# Access Compliance Report

### (Curb Ramps)

Intersection ID: 26654	Main Street: ALEXA_RD	Cross Street: OAK_POND_CR	Location: SW
ADA ID: 486932ADB833	Ramp Type: PerpDiag	Initial Pass/Fail: Fail	Overall Compliance: No
Severity Score: 13.75			
Codes/Mitigation Info/Possible Solution		Field Measurements/Component Compliance

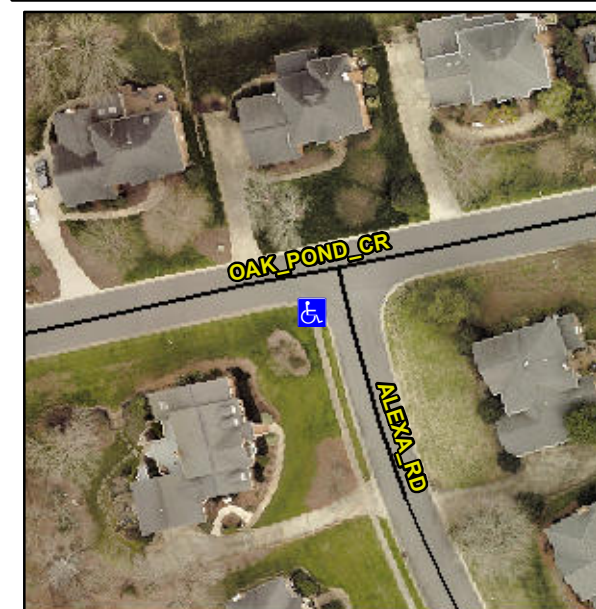
**Not Found, R304.2.2, R304.5.3**

Compliance	Description	Data	Compliance	Description	Data
N/A	Ramp Length (in)	48.0	No	Ramp Slope (%)	8.6
Yes	Ramp Width (in)	48.0	No	Ramp XSlope (%)	4.5
N/A	Flare Type LT	N/A	N/A	Flare Type RT	N/A
N/A	Flare Slope LT (%)	N/A	N/A	Flare Slope RT (%)	N/A
N/A	Flare Traversable LT?	N/A	N/A	Flare Traversable RT?	N/A
N/A	Landing Length (in)	N/A	N/A	DWS Provided?	N/A
N/A	Landing Width (in)	N/A	N/A	DWS Contrast?	N/A
N/A	Landing Slope (%)	N/A	N/A	DWS Length (in)	N/A
N/A	Landing X Slope (%)	N/A	N/A	DWS Full Width?	N/A
N/A	Landing Curb? (Y/N)	N/A	N/A	DWS Offset (in)	N/A
N/A	Shared Landing?	N/A			
N/A	Gutter Ponding?	N/A	N/A	Gutter Slope (%)	N/A
N/A	Gutter Lip Ht (in)	N/A	N/A	Gutter X Slope (%)	N/A
N/A	Painted X Walk1?	No	N/A	Painted X Walk2?	No
	X Walk 1 Direction	To E		X Walk 2 Direction	To N
N/A	X Walk 1 Width (in)	N/A	N/A	X Walk 2 Width (in)	N/A
	X Walk 1 Slope (%)	0.7		X Walk 2 Slope (%)	1.9
	X Walk 1 X Slope (%)	2.0		X Walk 2 X Slope (%)	0.4

**Remove & Replace Curb Ramp With Two New Directional Ramps or Equivalent.**
